GILES CORNER REPLAT 2

RECOMMENDATION REPORT

CASE NUMBER: 2012-SUB-07

RE: Application for Replat-Initial Review
Giles Corner Replat 2 (Replat of Lot 80A)

PRELIMINARY PLAT

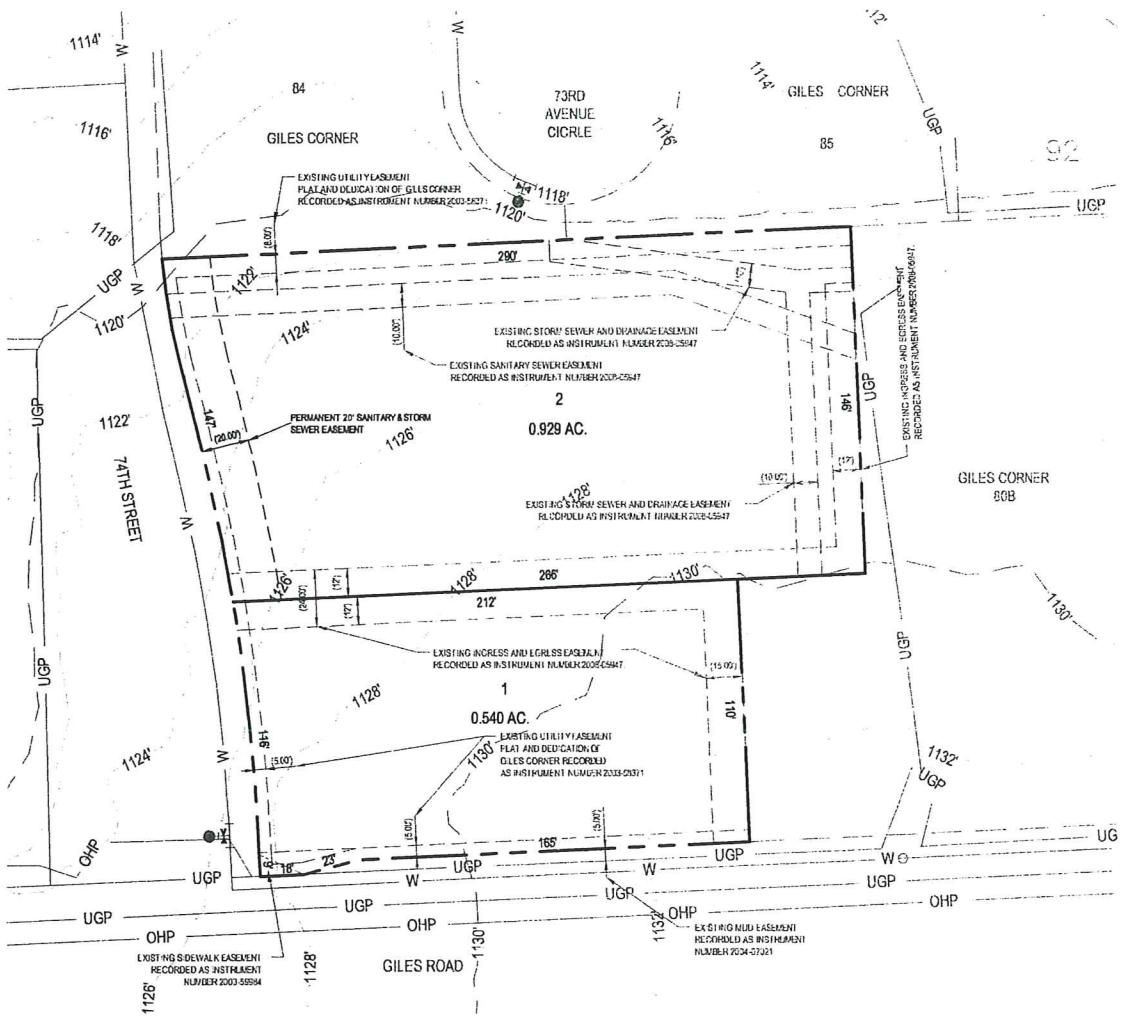
7. The preliminary plat was reviewed for compliance with Section 3.03 of the Subdivision Regulations. Items requiring further information are listed in the foregoing comments. Certain items are not applicable due to the nature of the proposed replat.

8. The final plat was reviewed for compliance with Section 3.03 of the Subdivision Regulations. Comments from that review are as follows:
 - a. The widths of adjacent right-of-ways abutting the plat need to be shown per Article 3.05.03 of the Subdivision Regulations.
 - b. The approval block for the Planning Commission is missing and needs to be added.
 - c. A signature block for the Register of Deeds needs to be provided.

SARPY COUNTY,
NEBRASKA
PRELIMINARY PLAT

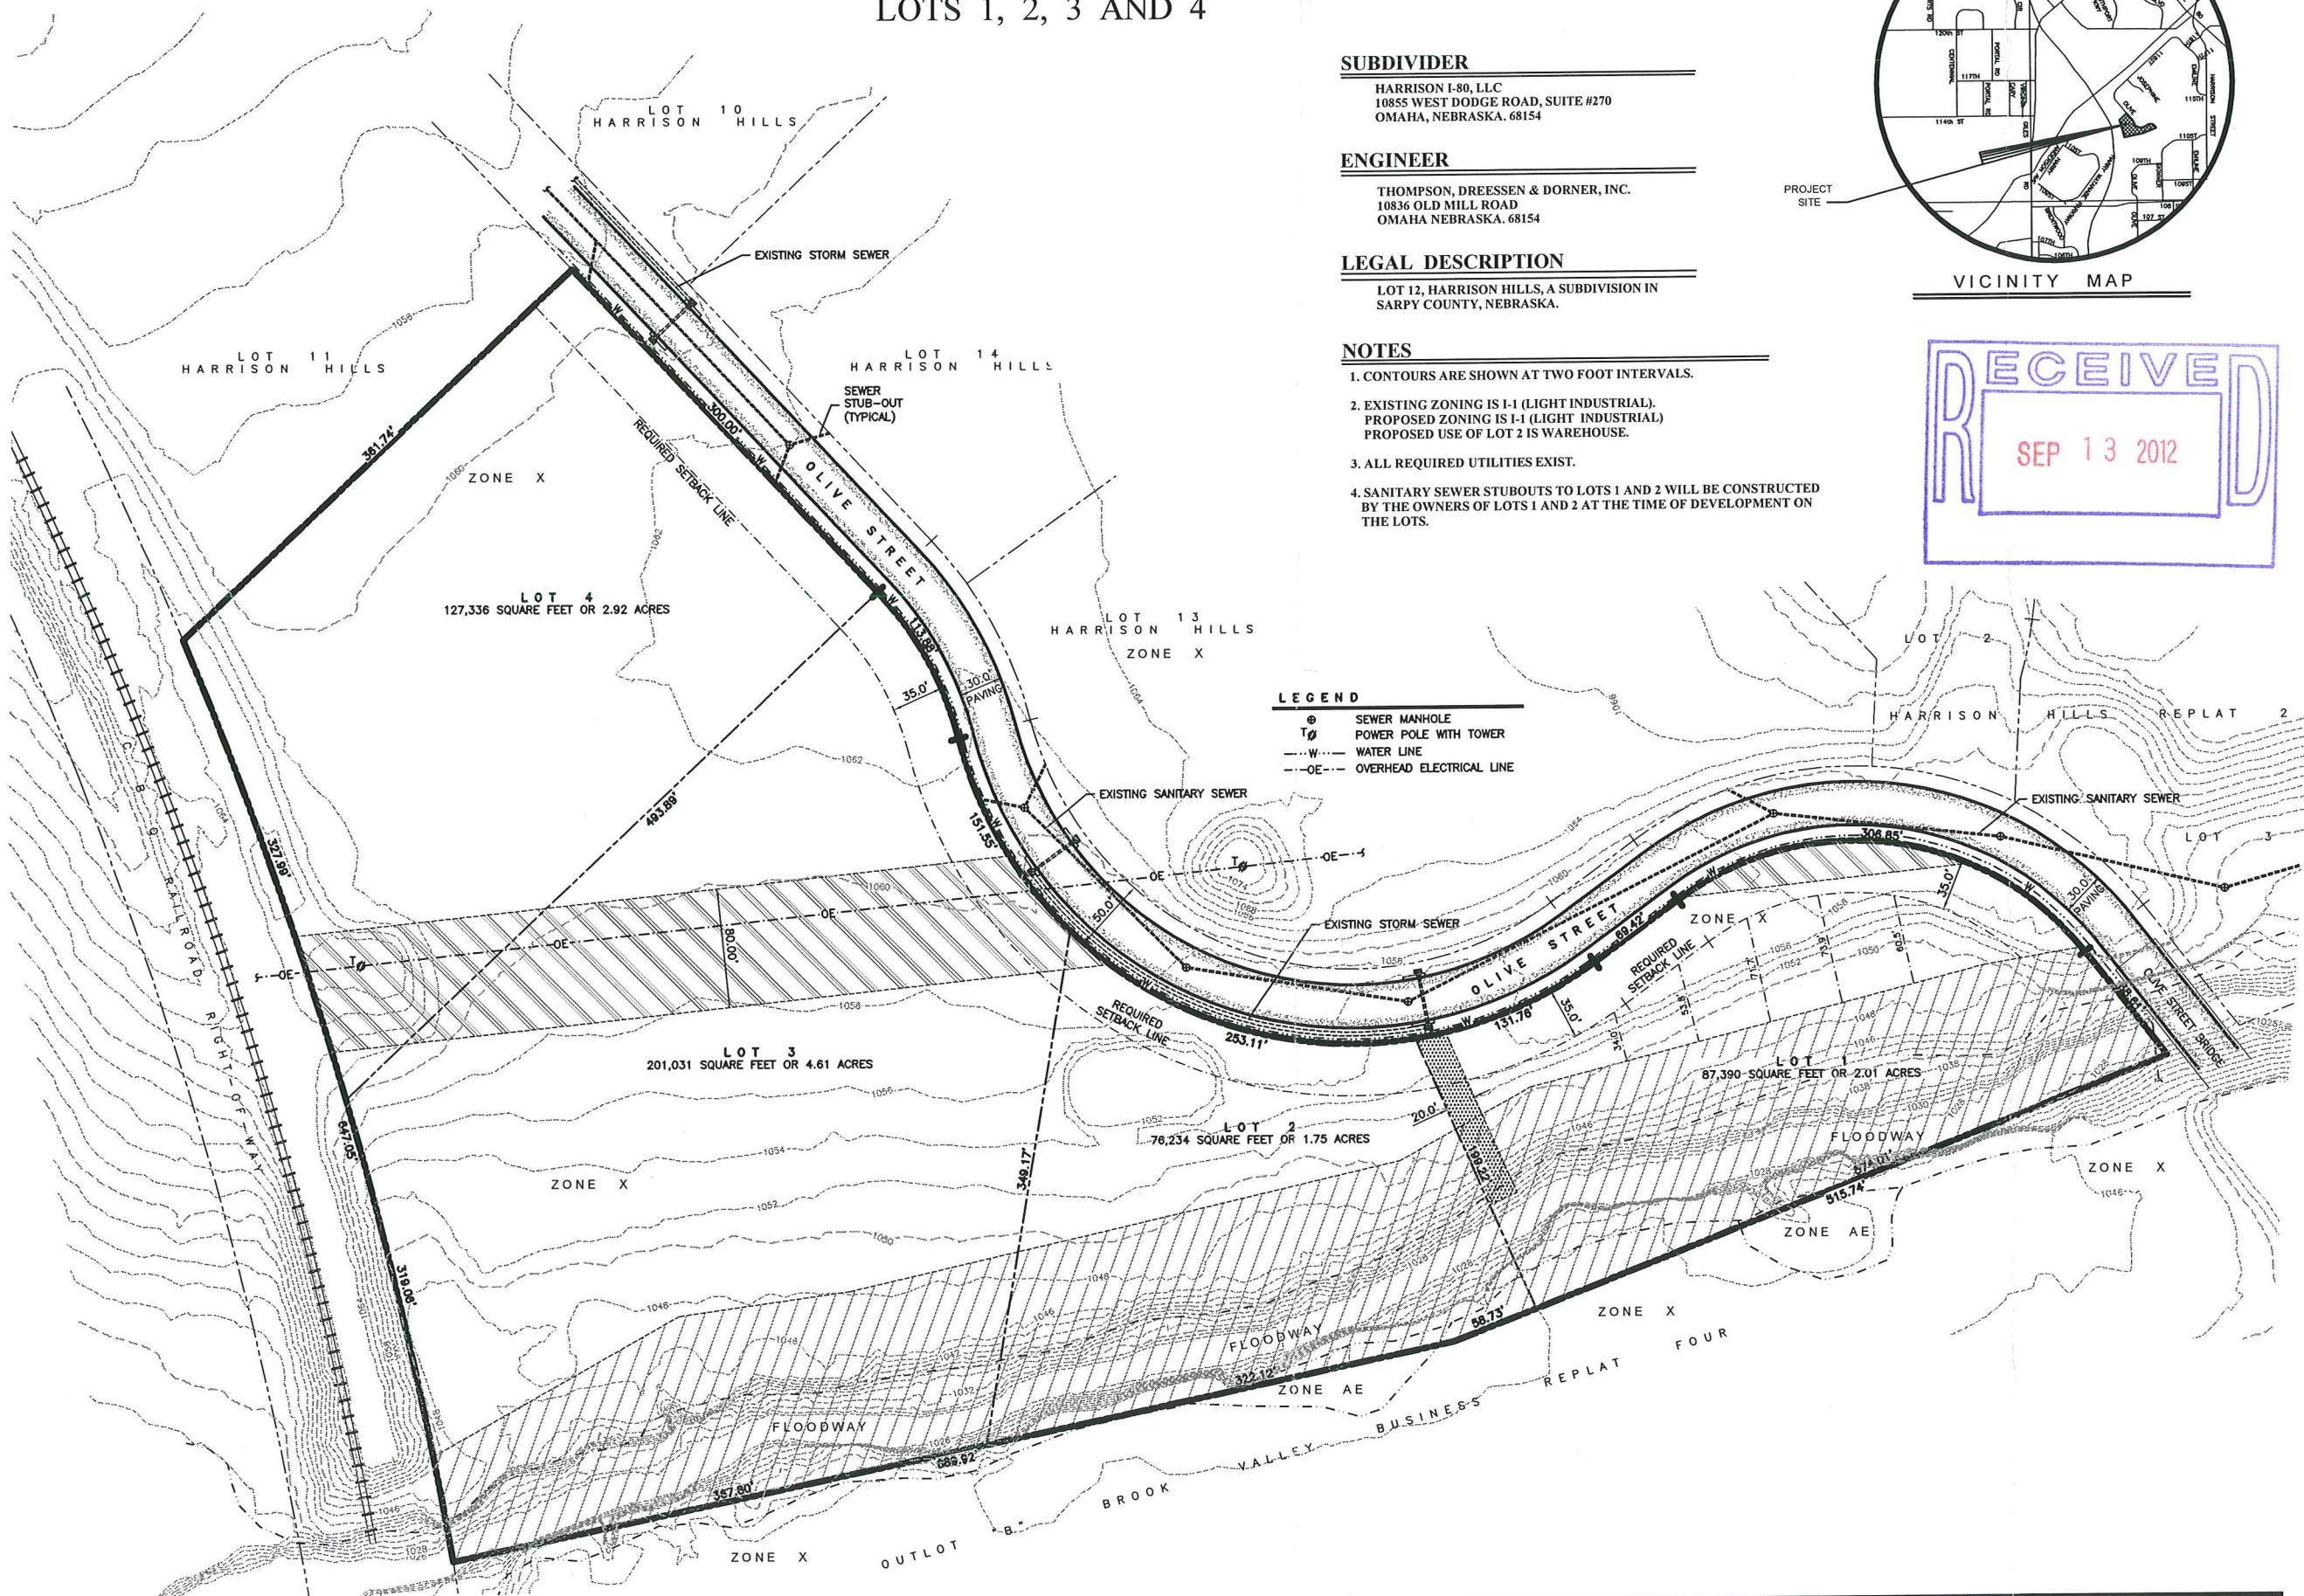
7. The preliminary plat was reviewed for compliance with Section 3.03 of the Subdivision Regulations. Comments from that review are as follows:
 - a. The existing contours need to be shown on the preliminary plat. These can be obtained from the Sarpy County GIS information or as-built records that the engineers for the applicant may have on file. This is needed in order to demonstrate the usable space and to identify the existing water course and/or ravines. Refer to Articles 3.03.03 and 3.03.07 of the Subdivision Regulations. Proposed contours will not be required since grading is not required to create the lots. Proposed contours will be required as part of building plans for each lot when built upon.
 - b. The location of the west end of the existing Olive Street bridge needs to be shown on the preliminary plat. See Article 3.03.07 of the Subdivision Regulations.

- c. Show the existing floodway and floodplain limits on the preliminary plat. See Article 3.03.13 of the Subdivision Regulations.

- a. The graphic scale on the final plat appears to be wrong. It is shown as 50 scale, but the drawing appears to be drawn at 60 scale.
- b. The approval block for the Planning Commission is missing and needs to be added.
- c. A signature block for the Register of Deeds needs to be provided.
